Technical Evaluation Report

U.S. Nuclear Regulatory Commission Technical Evaluation of the New York State Energy Research and Development Authority's Radiological Survey and Dose Assessment Report For the Western New York Nuclear Service Center and Off-Site Areas In Follow Up to Aerial Gamma Radiation Survey Conducted in 2014

April 5, 2018

Figure 1. Seneca Nation of Indians Sub-Areas and Larger Model Domain (a) Area 4 and (b) Area 5

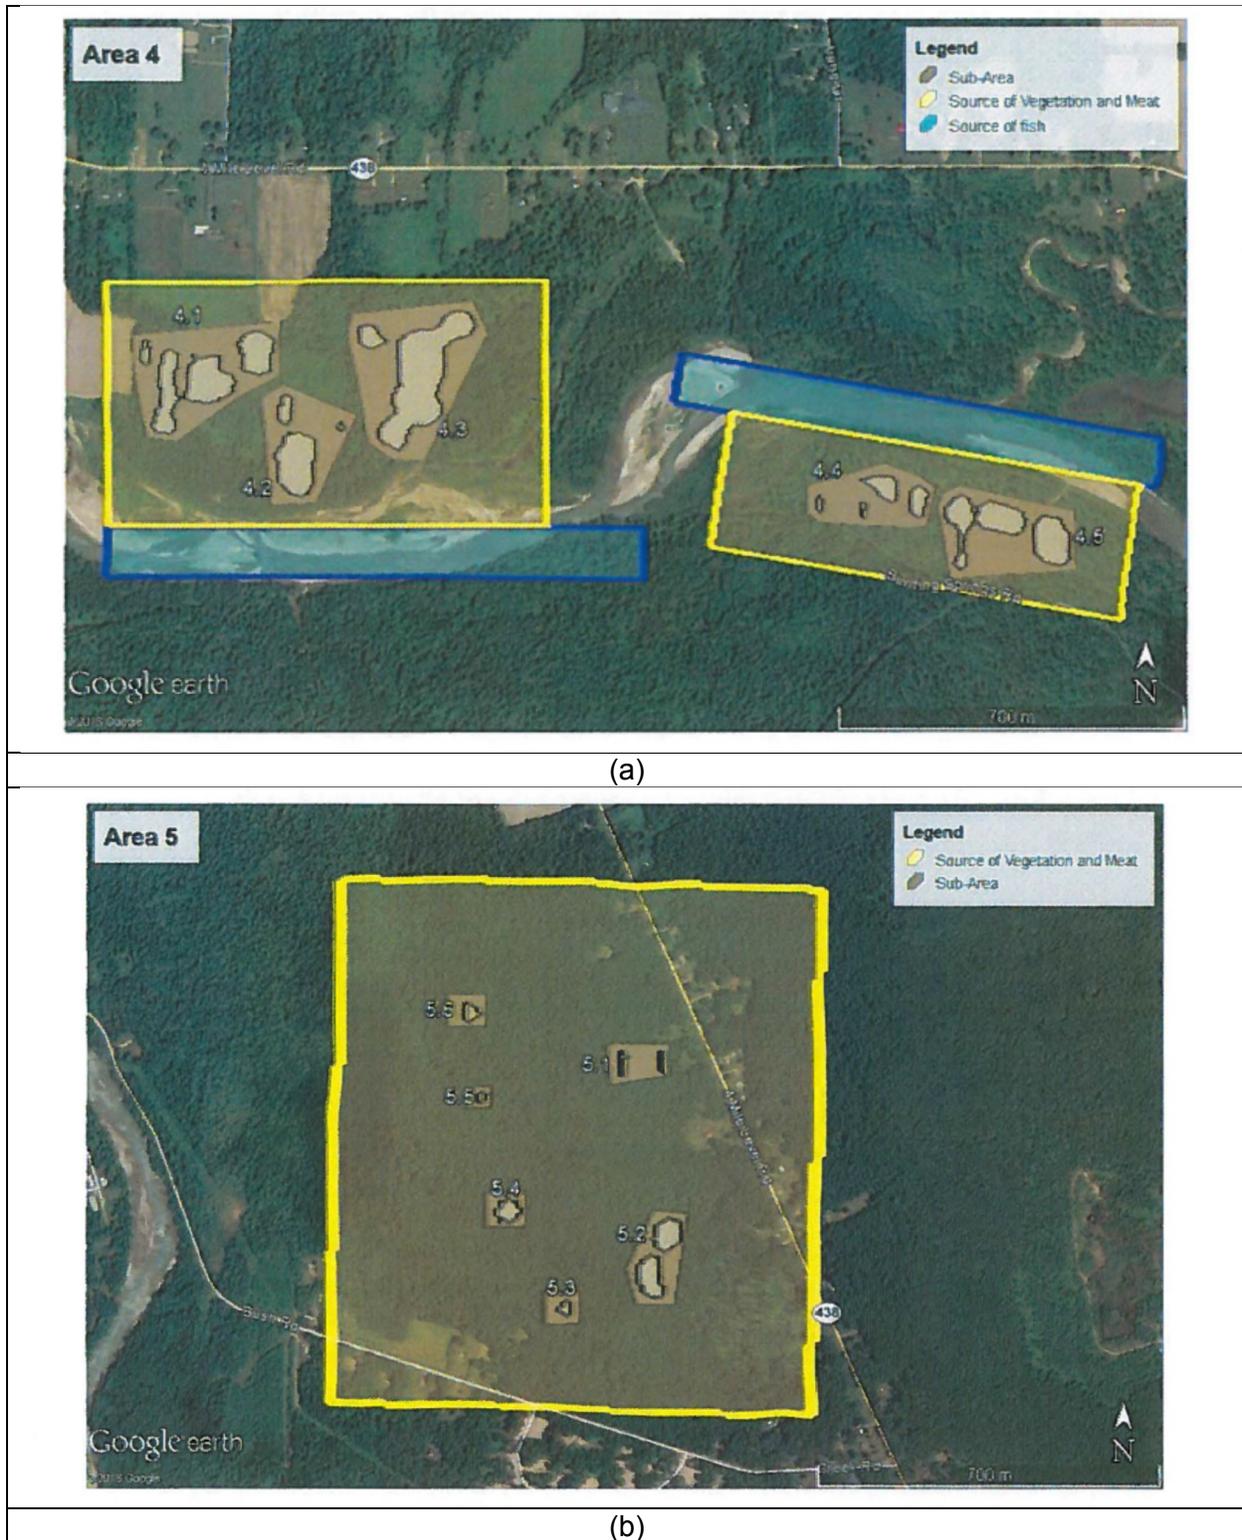
NYSERDA groups Sub-Areas 4.1 through 4.3 together in the same model domain (see Figure 1 of this TER); Sub-Areas 4.4 and 4.5 together; and Sub-Areas 5.1 through 5.5. However, NYSERDA does not include multiple sources in the same model domain but rather assumes that each individual source is located in the larger model domain which is absent any other sources. The staff evaluated a bounding scenario in which the sources in each of the model domains were assumed to be co-located and combined into a single, larger source using the maximum Cs-137 concentration from any soil interval within a group; and maximum, average gross alpha, and gross beta for any of the sub-areas within a group (i.e., Sub-Areas 4.1 through 4.3; Sub-Areas 4.4 and 4.5; and Sub-Areas 5.1 through 5.6 are grouped together). The total source area was assumed to overlap the model domain to efficiently evaluate (but significantly overestimate) the impact of this assumption on the results. Although the doses could be significantly higher, the doses were all significantly less than the unrestricted release limit. Therefore, the staff has confidence that any non-conservatisms in the conceptual model will not impact the conclusion regarding the low risk of the areas of offsite radioactivity.

Figure 2. Example RESRAD OFFSITE Conceptual Model for Area 1

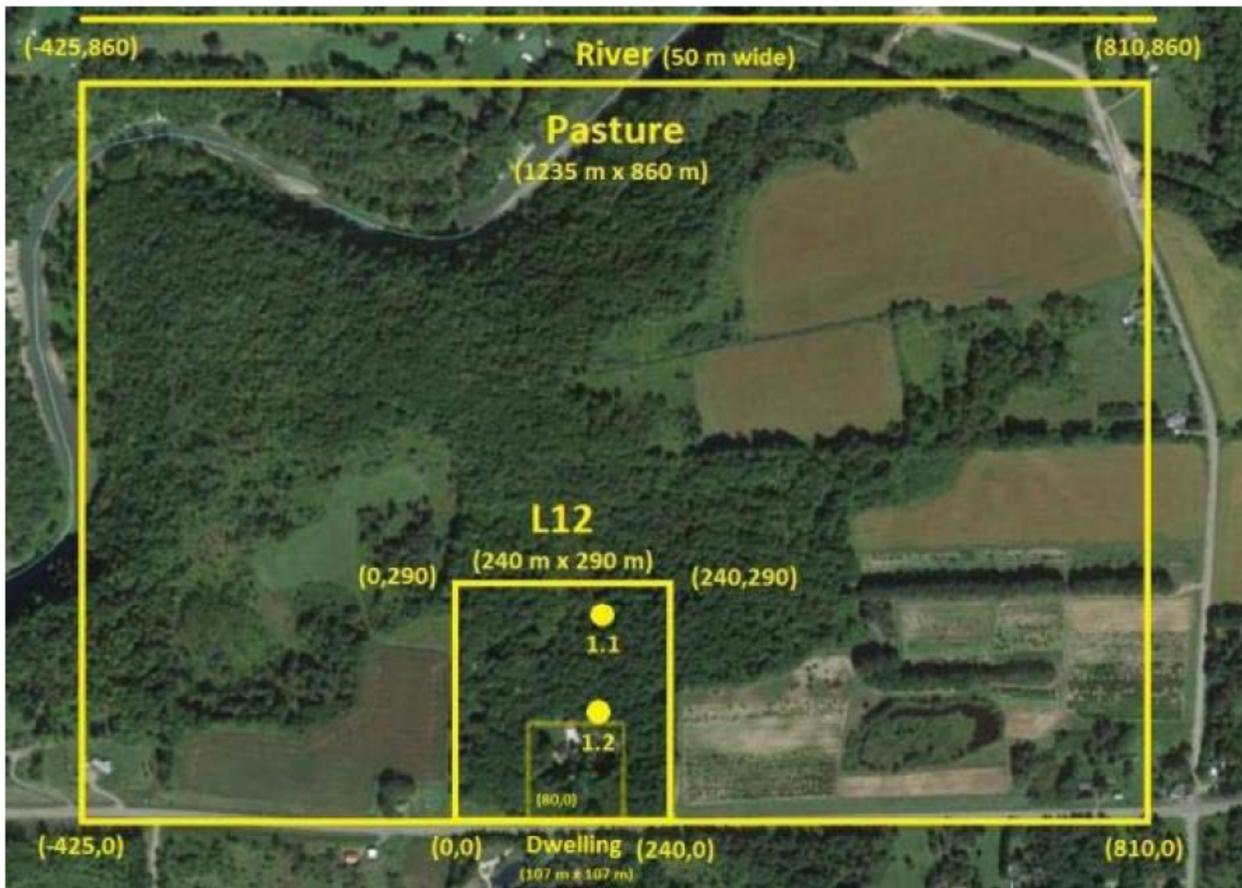
NYSEDA described and illustrated the RESRAD OFFSITE model domains for each of the exposure areas in its dose assessment report (e.g., see Figure 2 below from the submittal).

However, in some cases, the location of groundwater wells and groundwater flow direction appeared to be based on default specifications. In cases where the flow direction was based on default specifications, the distance from the downgradient edge of the contaminated zone to surface water did not appear to be correctly specified. Nonetheless, the impact of use of default parameter values and distance specifications did not have a significant impact on the results due to a general lack of importance of water dependent pathways (in many cases the external dose or direct plant ingestion pathways dominated the risk from the evaluated areas). Although land use surveys provided in Appendix D of NYSERDA's submittal alluded to the presence of groundwater wells in Areas 1 and 4, the wells in Area 1 appeared to be located up-gradient of the elevated areas (west, south, or southwest of the elevated areas) and would therefore, not impact the dose assessment. The wells in Area 4 were stated to be located "adjacent" to the sampled area and were used for field irrigation only. The groundwater well in the RESRAD OFFSITE model domain was placed between the contaminated zone and surface water with a groundwater flow direction from the contaminated zone to surface water. However, the default distances from the contaminated zone to the well and surface water were used rather than allowing RESRAD OFFSITE to calculate the distances. Based on land use surveys, no wells appear to be located in Areas 2, 3, Subareas 4.4 and 4.5; and Area 5. In Areas 2 and 3; and Subarea 4.4 and 4.5, however, a well was conservatively placed in the RESRAD OFFSITE model with the default specifications. Additionally, as recommended by the staff in the June 2016 audit (NRC, 2016), NYSERDA evaluated reasonably foreseeable future land use using the RESRAD (onsite) code for Areas 1, 2, and 3. The built-in conceptual model in RESRAD assumes that the groundwater well is located on-site and the surface water is downgradient of the contaminated zone, leading to potentially higher estimates of dose through groundwater-dependent pathways, should such doses have been potentially underestimated in the RESRAD OFFSITE calculations. Therefore, the impact of conceptual model inaccuracies was mitigated through use of a more conservative hydrological model in supplementary RESRAD calculations.

Figure 3. Example Use of Google Earth to Identify Attributes of Areas of Interest

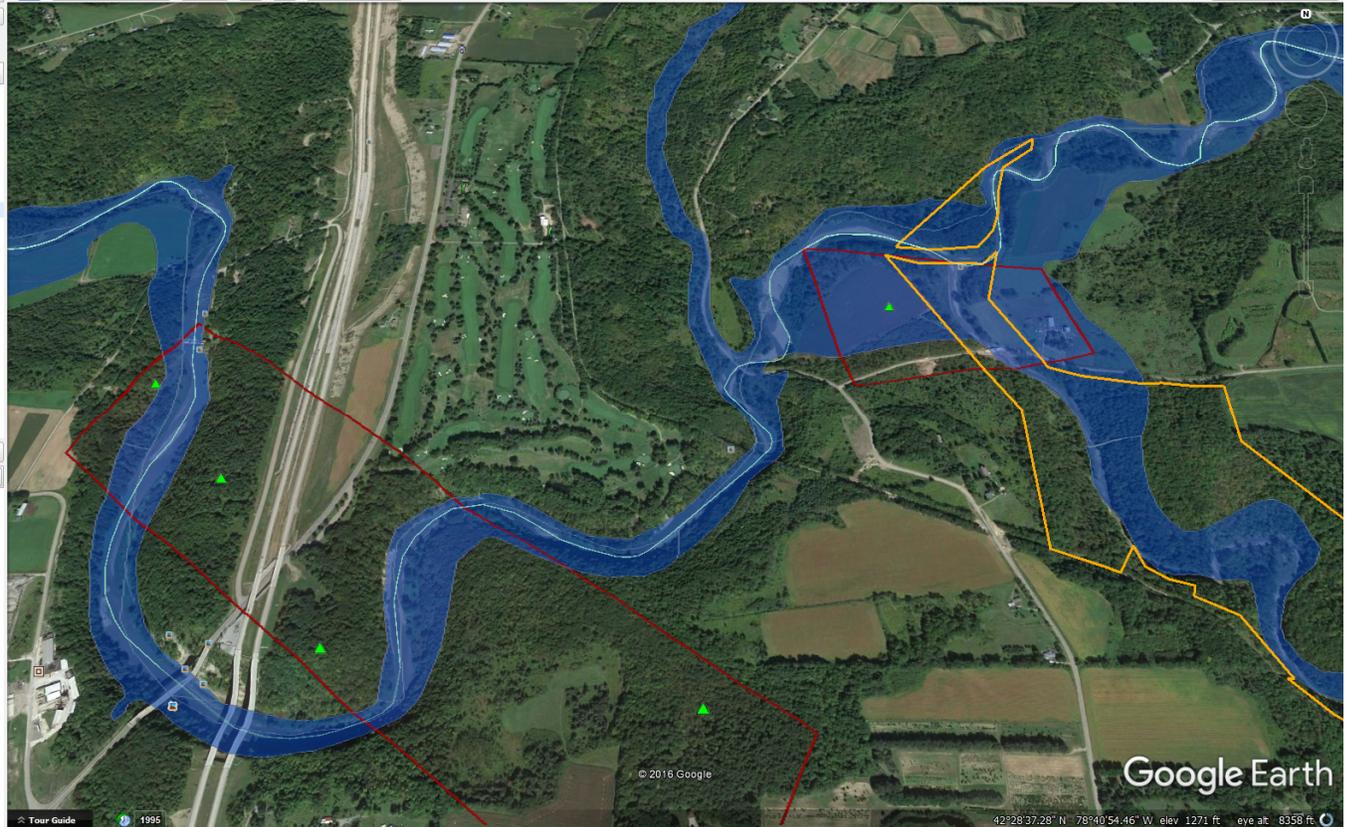
As part of its independent analysis, the staff also used GIS tools to map the areas of interest and determine current land use and other important attributes such as topography, grade, land cover, proximity to surface water/flood plains, location of residences, and other important features (see Figure 3 of this TER). The staff reviewed NYSERDA's selection of current land use scenarios and determined that the scenarios selected were reasonable. In one case (for Sub-Area 2.1), NYSERDA eliminated consideration of a resident scenario due to the steep topography. The staff confirmed that the slope of the land would not be conducive to residential construction. Although residences were located in nearby areas that had a more flat terrain, due to the steep terrain, NYSERDA's elimination of the resident scenario is reasonable.
